SITE AUDIT REPORT

ROAD INFRASTRUCTURE

AT 1C SYDNEY STEEL

ROAD, MARRICKVILLE

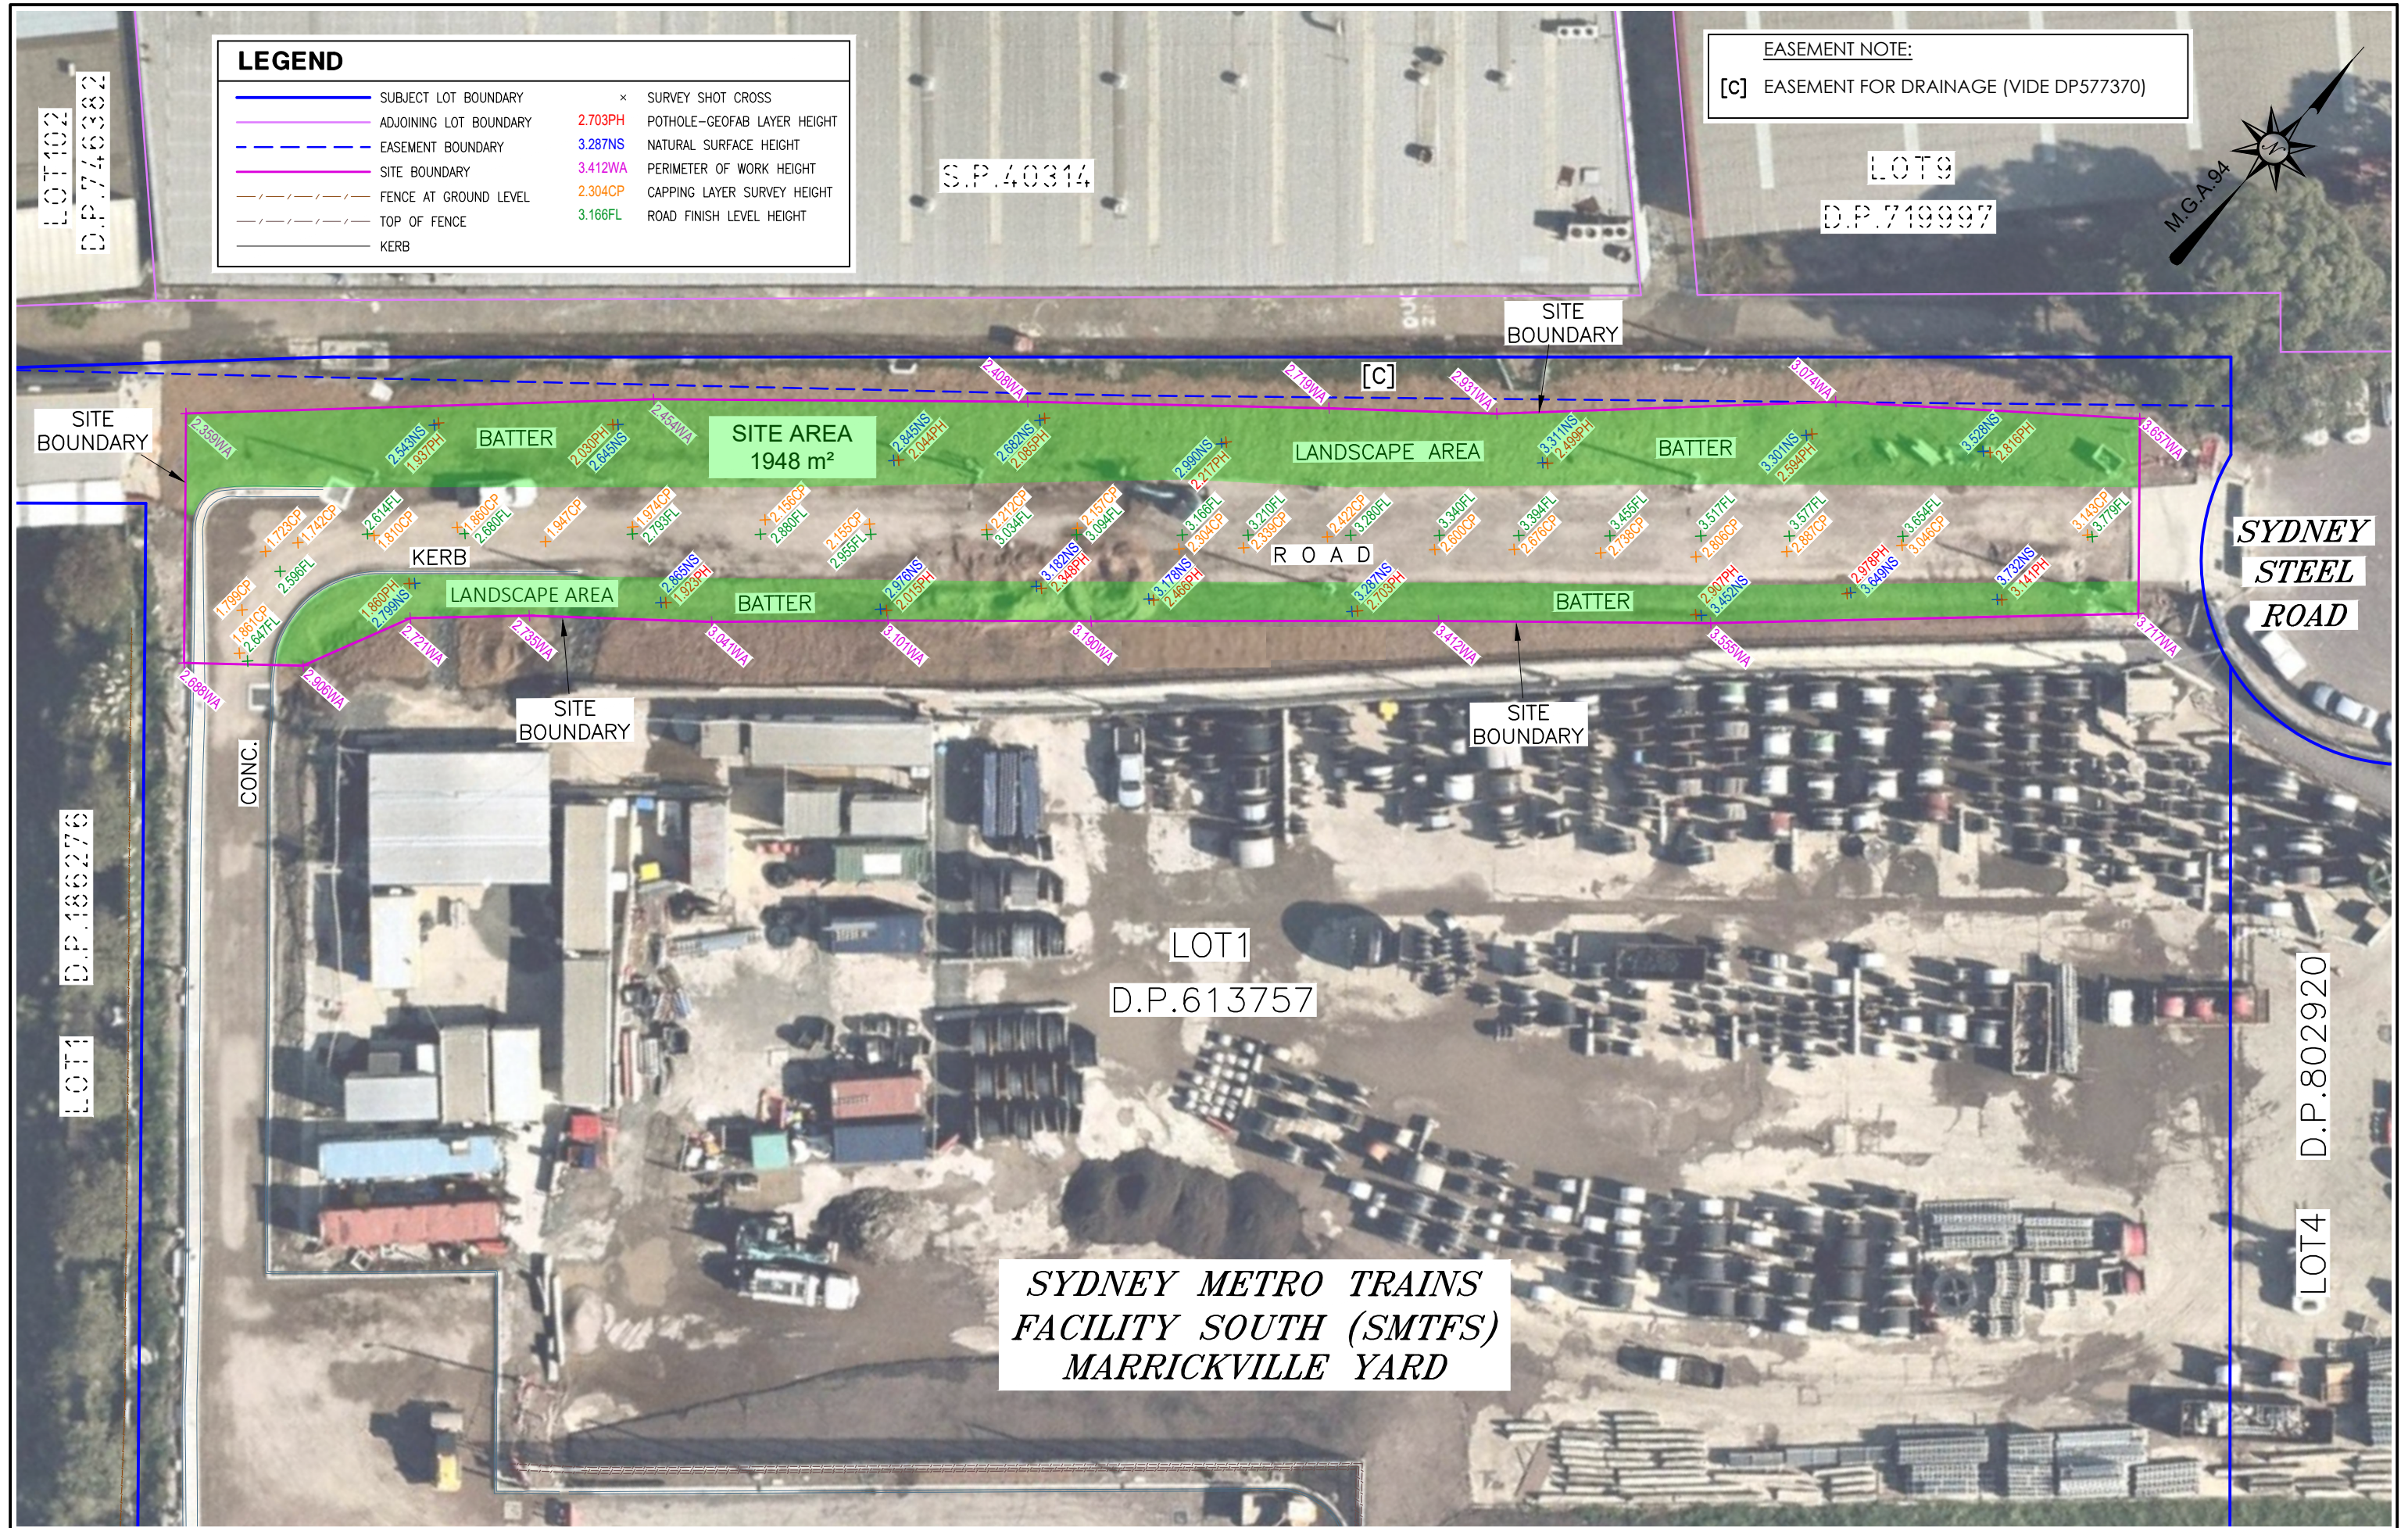
Based on the information presented in the survey plan, Alliance noted that the thickness of capping placed above the marker layer in the road portion of the site ranged from approximately 0.61 to 0.94 m while the thickness of capping placed above the marker layer in the landscaped areas of the site ranged from approximately 0.55 to 0.96 m.

Alliance reported that the capping thickness at two locations within the road portion of the site near the western boundary marginally did not meet the planned thickness (0.683 m) specified in the RAP. Alliance considered that *".....although the planned thickness of the capping layer was not achieved, the actual thickness and material type (engineered subgrade and hardstand pavement) is sufficiently adequate to break the exposure pathway between identified sources and receptors on site, based on the proposed land use scenario, subject to ongoing management of that capping layer."*

Cross-Sectional View of Capping Layers

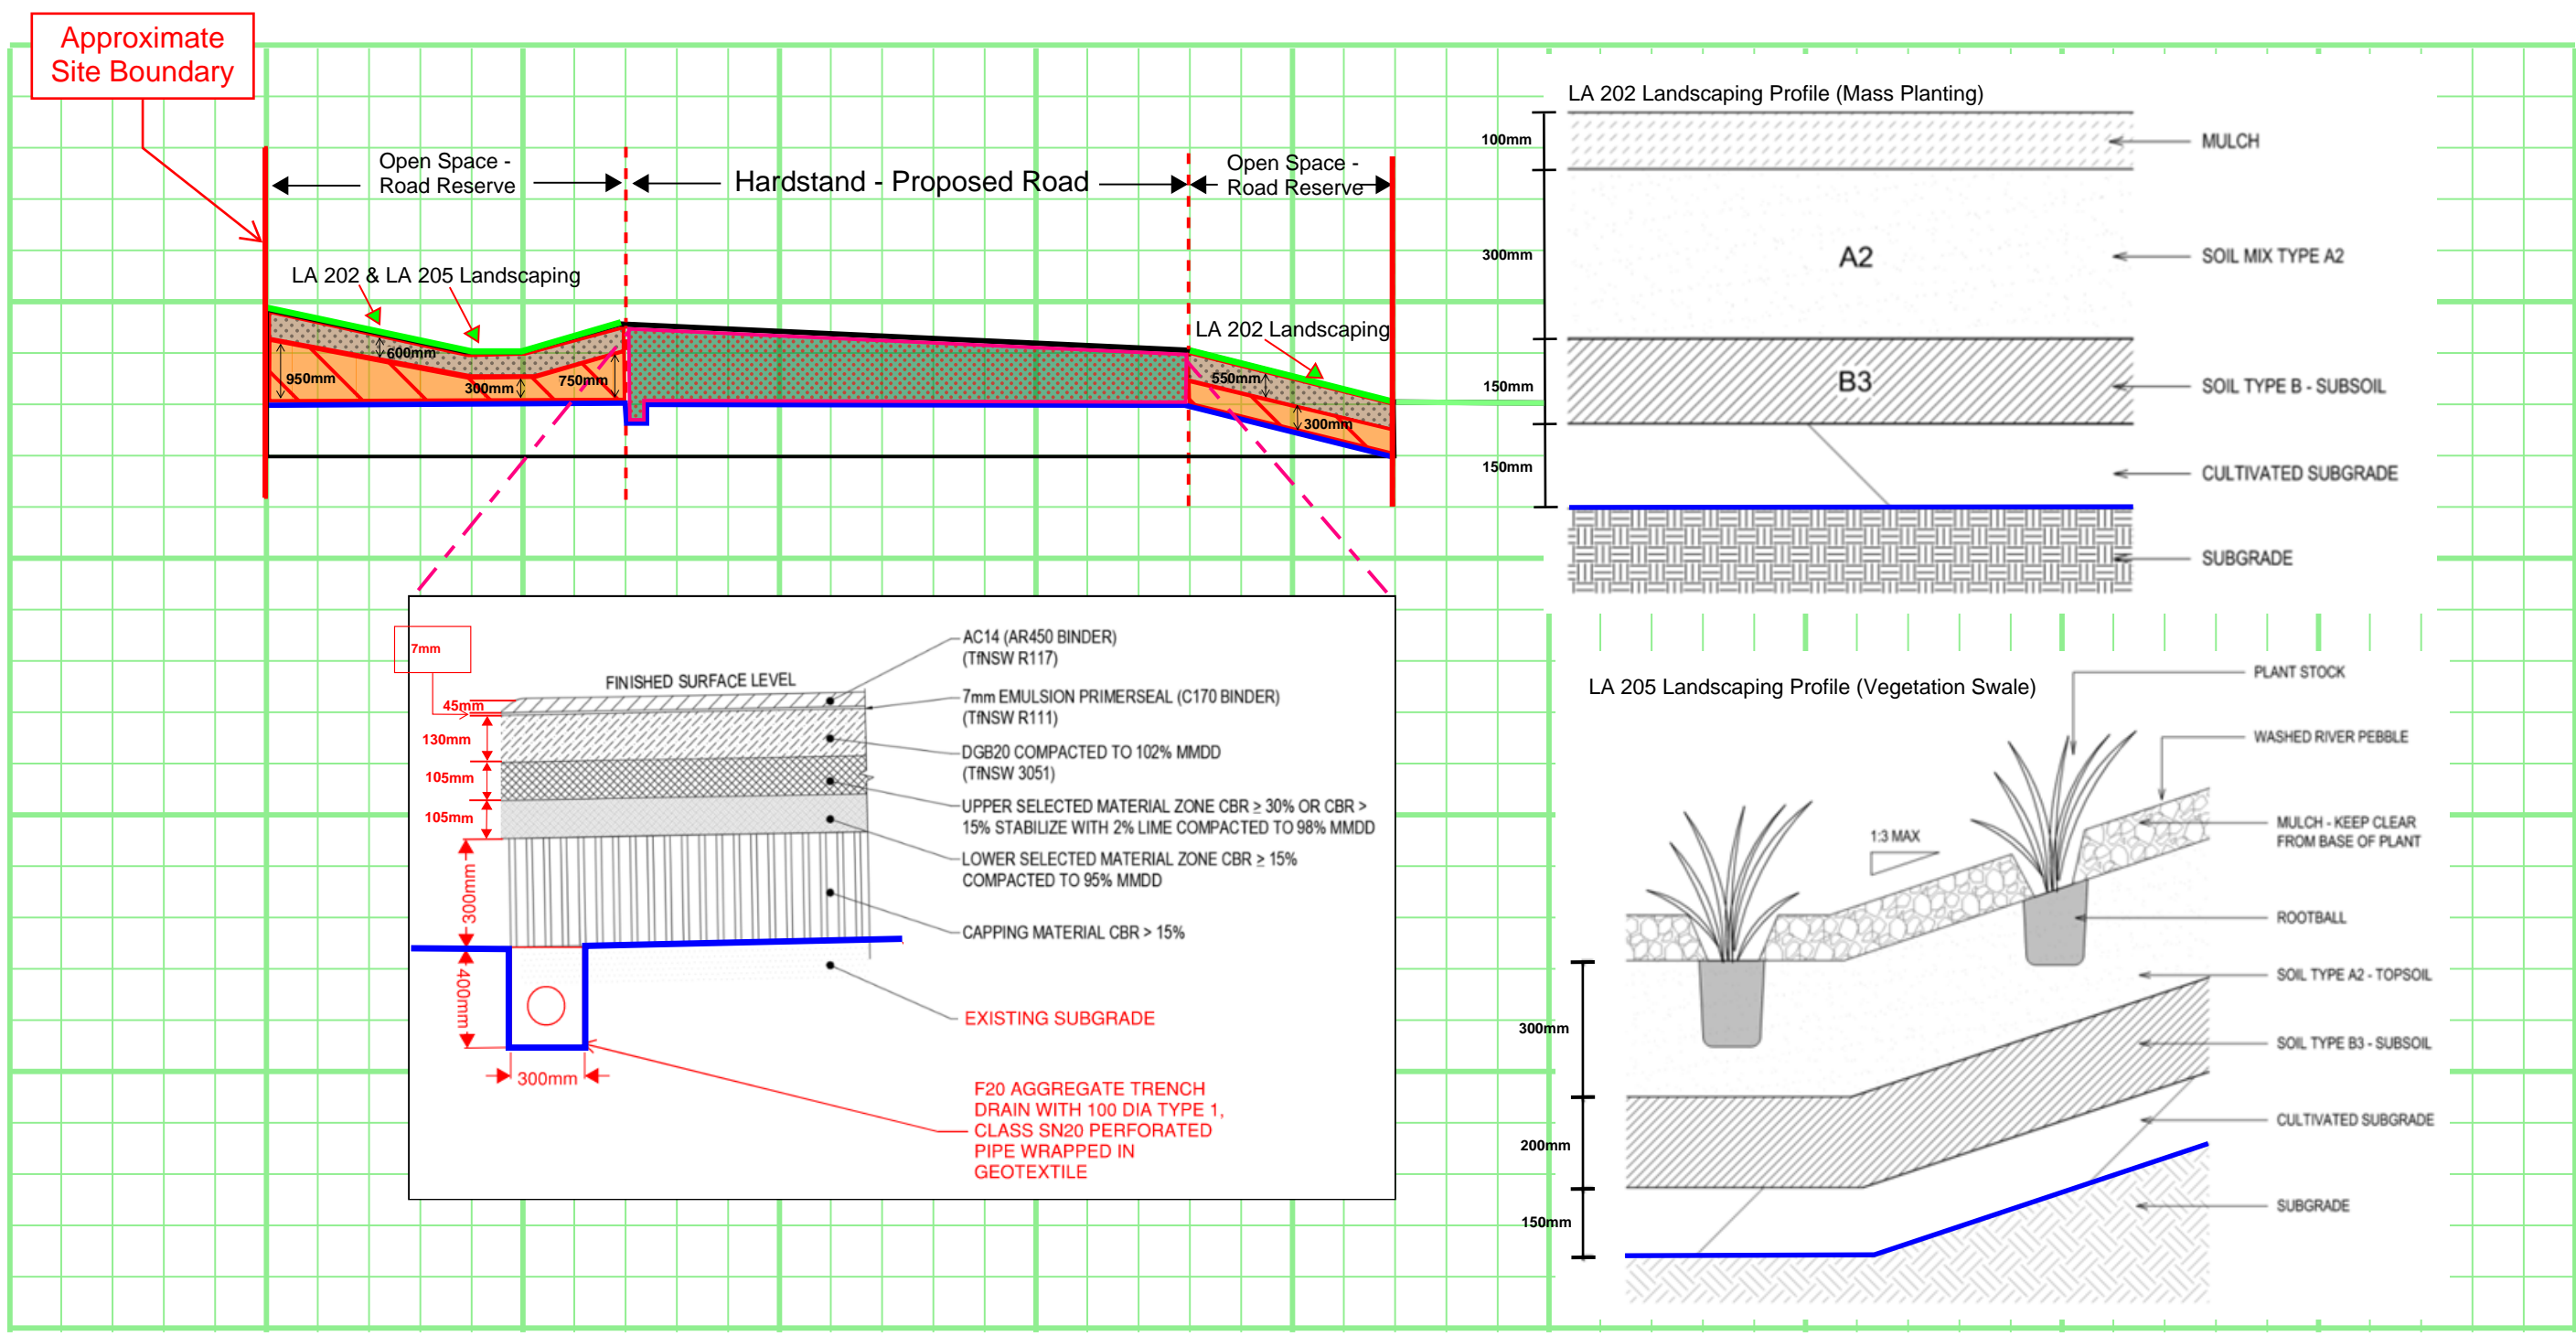
Item	Auditor Comments
<p>comprised grey/dark grey gravelly sand, topsoil followed by planting of grasses/shrubs and surface mulch/woodchips.</p> <p>Typical cross-sections of the capping specifications were included in the EMP and are shown in Attachment 8, Appendix A.</p>	
<p><i>Management Activities</i></p> <p>Section 7 of the EMP identifies management activities and management procedures for any future works (including installation/maintenance of services and landscaping) with the potential for disturbance of capped contaminated fill.</p> <p>Inspections will be undertaken every 6 months across the surface of the site to document the condition of the cap including the nature and extent of any grass dieback, erosion, potholes or cracking. Additional inspections will be undertaken following periods of heavy/prolonged rainfall or after works on site that disturb the capping layer.</p> <p>The EMP will be incorporated in the Operational Environmental Management Plan (OEMP), which has been prepared to address the SSI 7400 conditions of approval.</p> <p>On the basis that the methods do not require human intervention to ensure the ongoing performance, the management of residual contamination under the EMP was considered by Alliance to be passive in nature.</p> <p>Section 7.10 of the EMP outlined a contingency plan should the management strategy not perform. These contingencies include removal of the capping material, and reinstating with an alternatively designed capping system, and treatment of the impacted soils in a way that reduces the unacceptable land contamination risk to an acceptable level.</p>	<p>The Auditor notes that management activities are not required unless excavation activities are proposed beneath capping layers. The management activities outlined in the EMP are considered appropriate.</p> <p>Evidence has been provided that the EMP will be incorporated into the OEMP for the ongoing operation of the site (Appendix C).</p>
